World Forum for Harmonization of Vehicle Regulations

Working Party on Passive Safety

Forty-seventh session

Report of the Working Party on Passive Safety on its forty-seventh session

Figure 1:
Measurement of Vb, V1, V2.

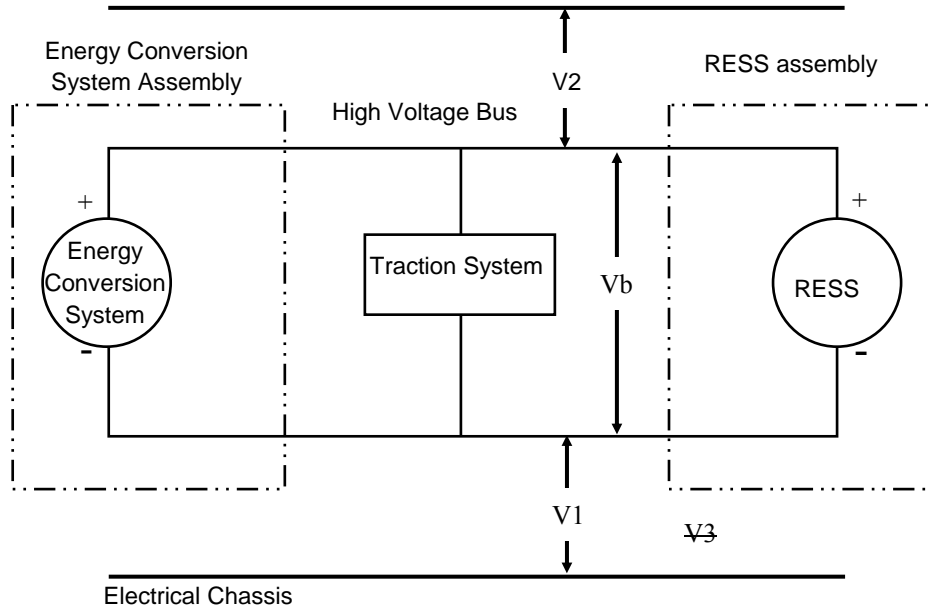
Before the vehicle **impact test conducted, the high** voltage bus voltage (Vb) (see figure 1) **shall be measured and recorded to confirm** that it is within the operating voltage of the vehicle **as specified** by the **vehicle** manufacturer.

After the **impact** test, determine the high voltage bus voltages (Vb, V1, V2) (see figure 1).

The voltage measurement shall be made not earlier than 5 seconds but not later than 60 seconds after the impact.

Figure 2

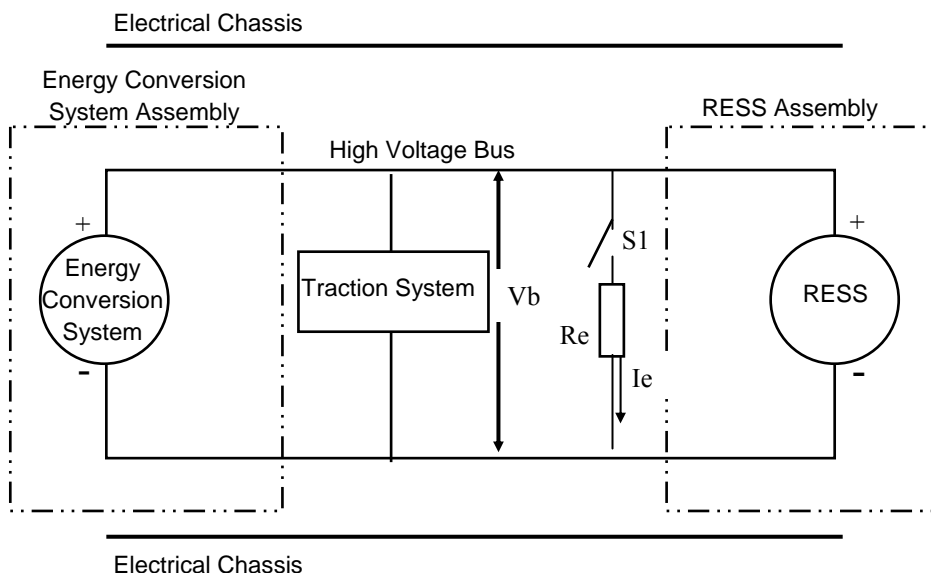
Prior to the impact a switch S1 and a known discharge resistor Re is connected in parallel to the relevant capacitance (ref. figure 2).

Figure 3

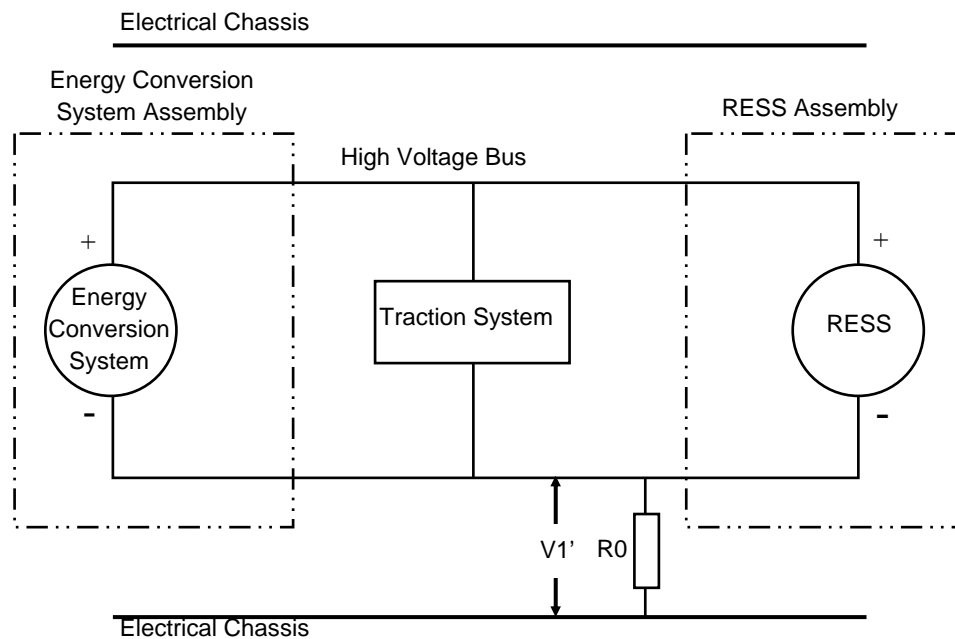
If V_1 is...electrical chassis (see figure 3). Calculate...formula shown below.

Figure 4
Measurement of V_2'

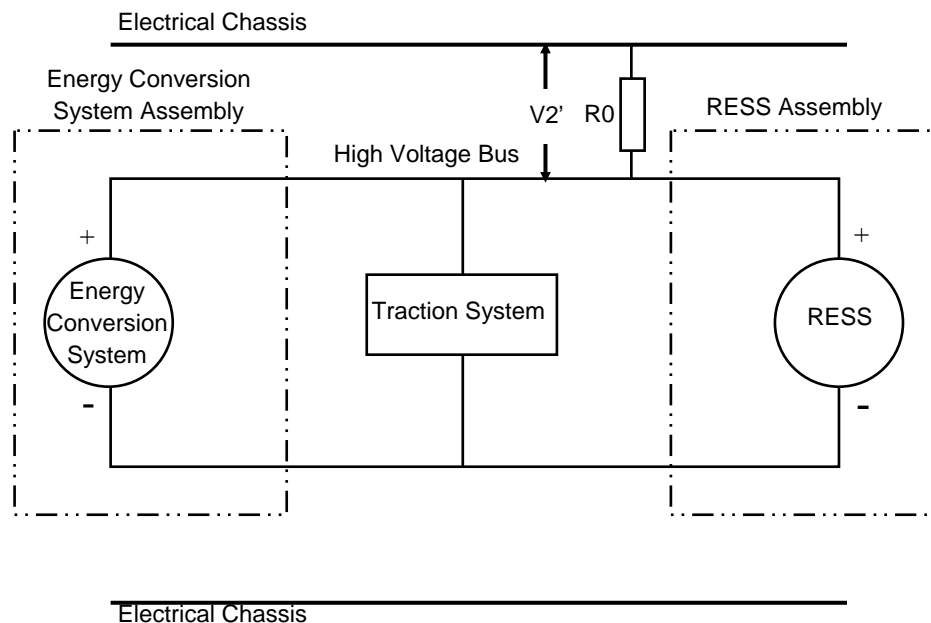
If V_2 is greater...electrical chassis (see figure 4).

Divide the result R_i , which is the electrical isolation resistance value in ohm (Ω) by the working voltage of the high voltage bus in volt (V).

Figure 1
Jointed test finger

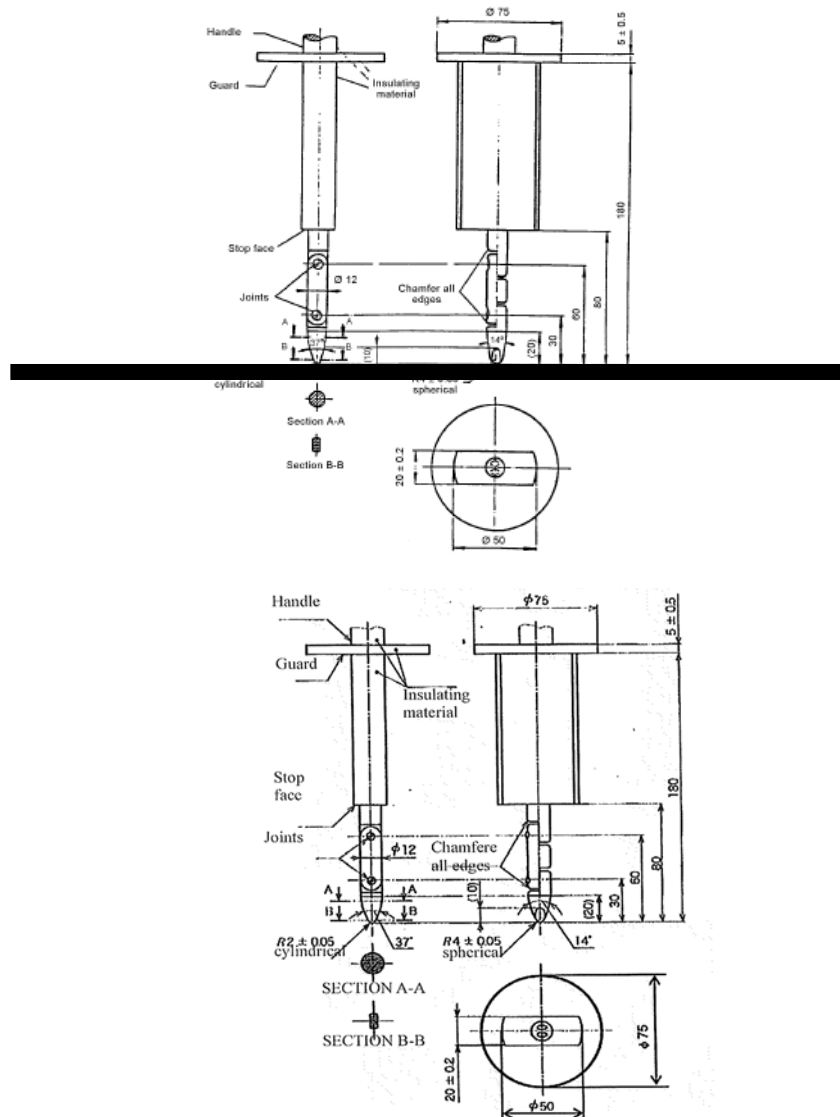
Jointed test finger (IPXXB), shall be deleted

Figure 1
Measurement of V_b , V_1 , V_2

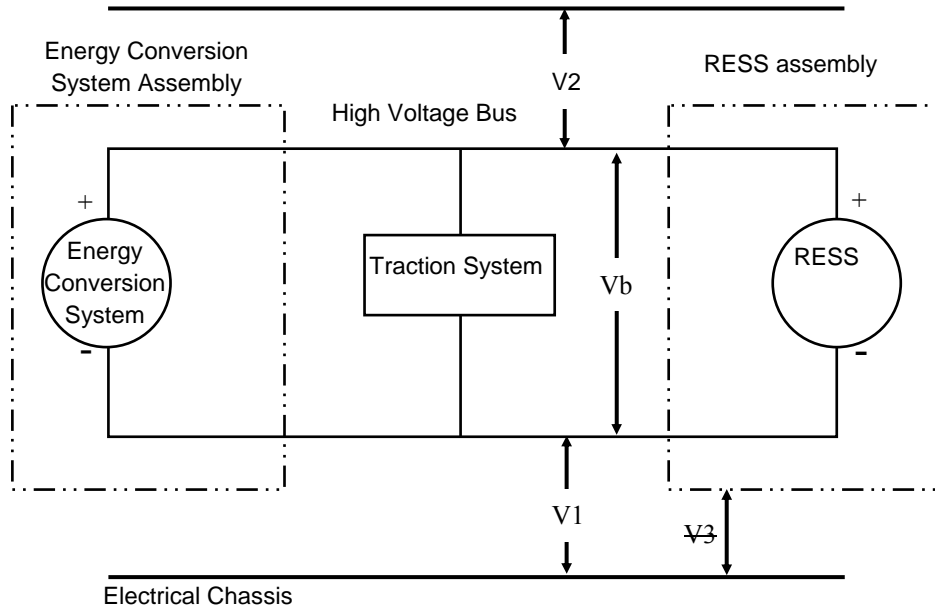
Before the vehicle **impact** test **conducted**, the high voltage bus voltage (Vb) (see figure 1) **shall be measured and recorded to** confirm that it is within the operating voltage of the vehicle as **specified** by the **vehicle** manufacturer.

After the **impact** test, determine the high voltage bus voltages (Vb, V1, V2) (see figure 1).

The voltage measurement shall be made not earlier than 5 seconds, but, not later than 60 seconds after the impact.

Figure 2

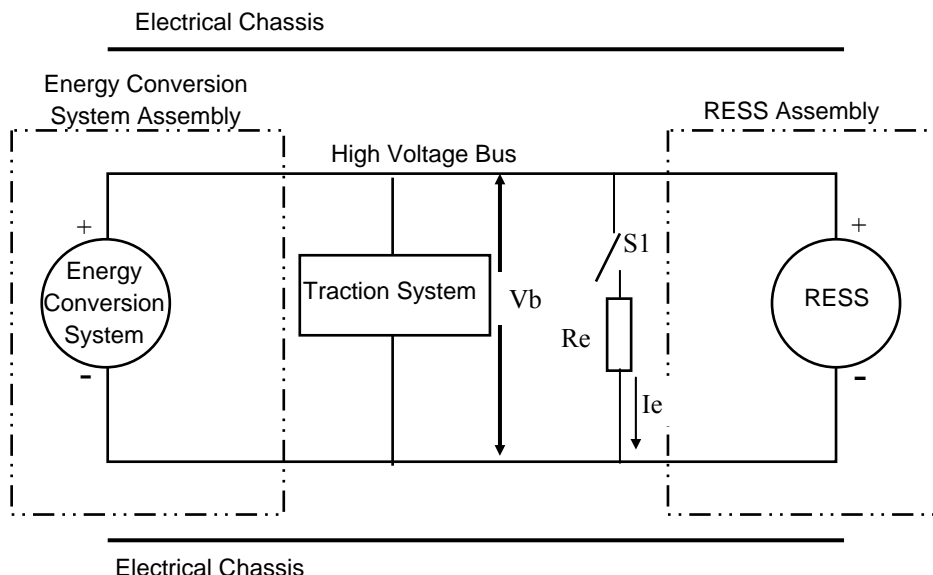
Prior...Re is connected in parallel to the relevant capacitance (ref. figure 2).

Figure 3

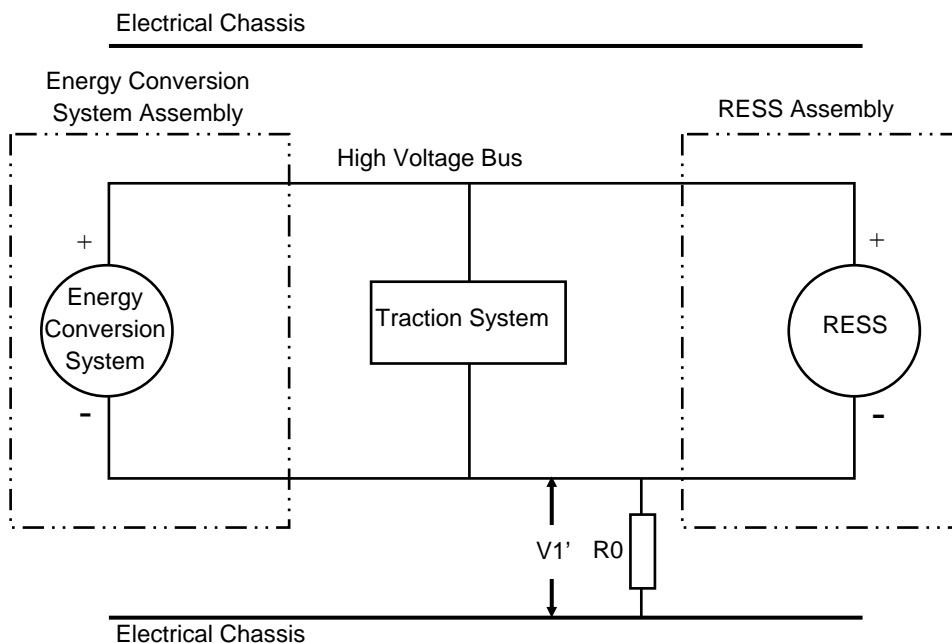
If V_1 is greater ... chassis (see figure 3)... the formula shown **below**.

Figure 4
Measurement of V2'

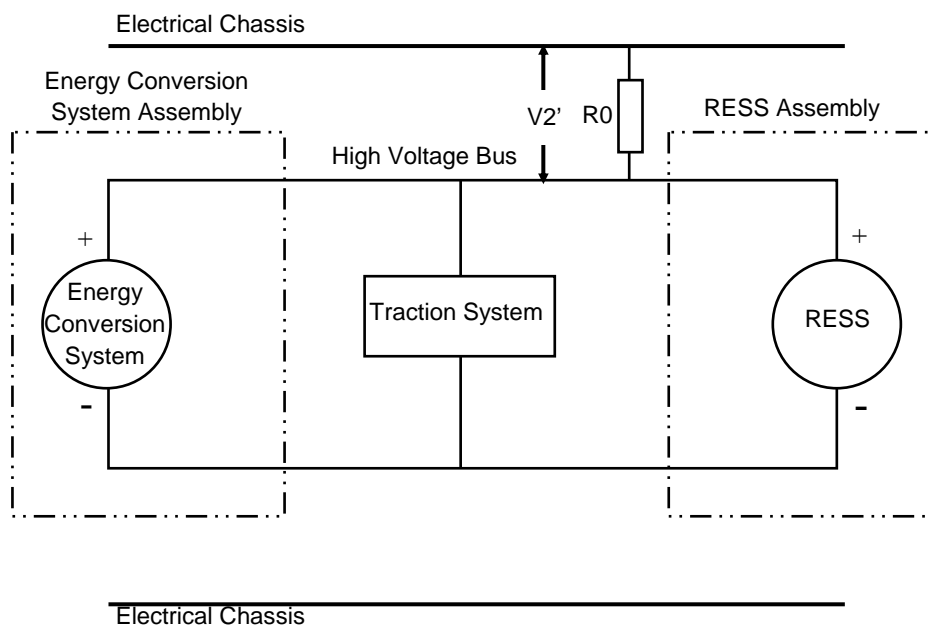
If V2 is greater...chassis (see figure 4).

Divide **the result Ri, which is the electrical isolation resistance** value in ohm (Ω), by....voltage **bus in volt (V)**.

Figure 1
Measurement of Vb, V1, V2

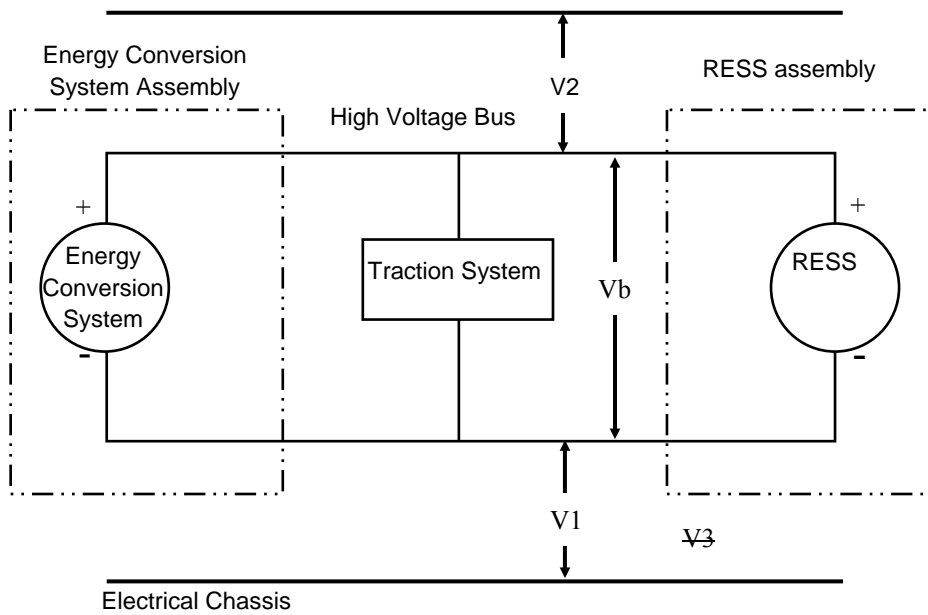
Before the vehicle **impact** test **conducted**, the high voltage bus voltage (Vb) (see figure 1) **shall be measured and recorded to confirm...vehicle as specified by the vehicle manufacturer.**

After the **impact** test, determine the high voltage bus voltages (Vb, V1, V2) (see figure 1).

The voltage measurement shall be made not earlier than 5 seconds, but, not later than 60 seconds after the impact.

Figure 2

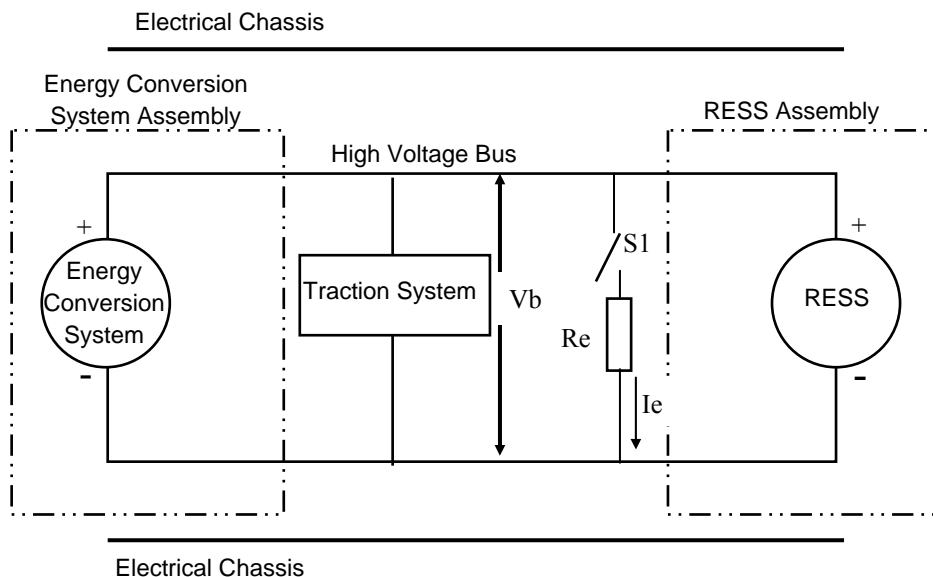
Prior to the impact a switch S1 and a known discharge resistor R_e is **connected in parallel to the relevant capacitance (ref. figure 2).**

Figure 3

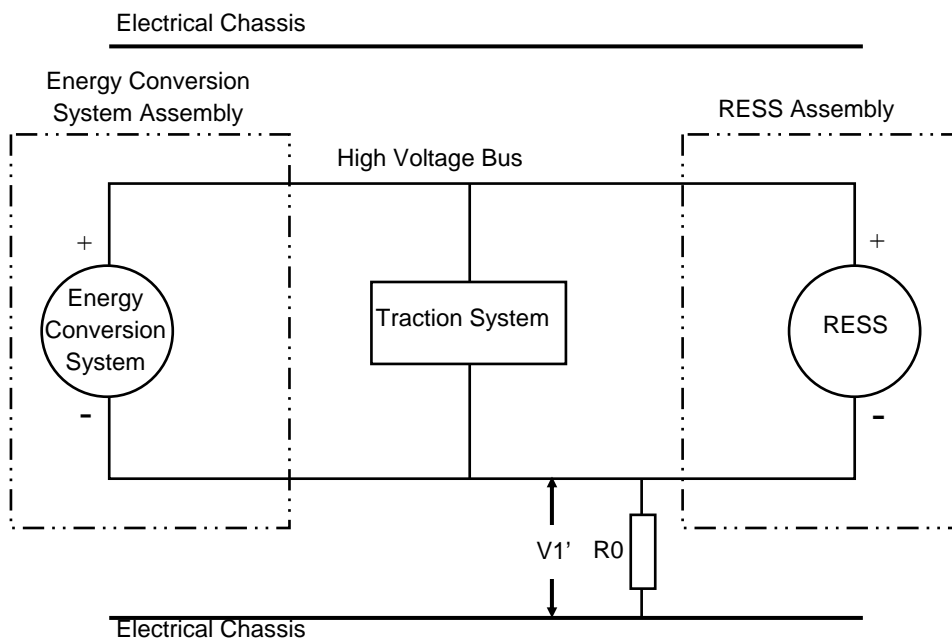
If V_1 is...chassis (see figure 3)... shown **below**.

Figure 4
Measurement of V_2'

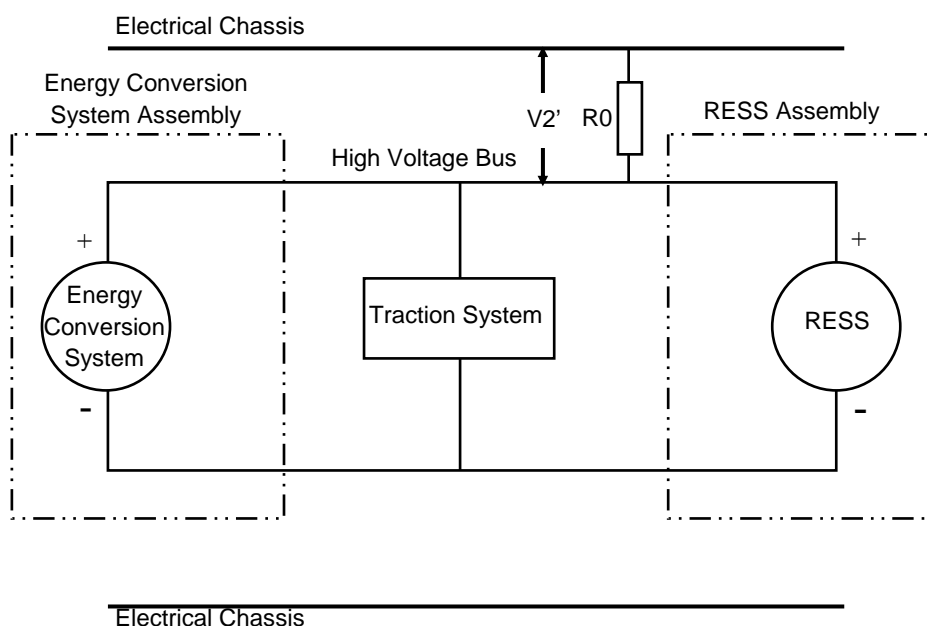
If V_2 is...chassis (see figure 4).

$$R_i = R_o \cdot (V_b/V_2' - V_b/V_2) \quad \text{or} \quad R_i = R_o \cdot V_b \cdot (1/V_2' - 1/V_2)$$
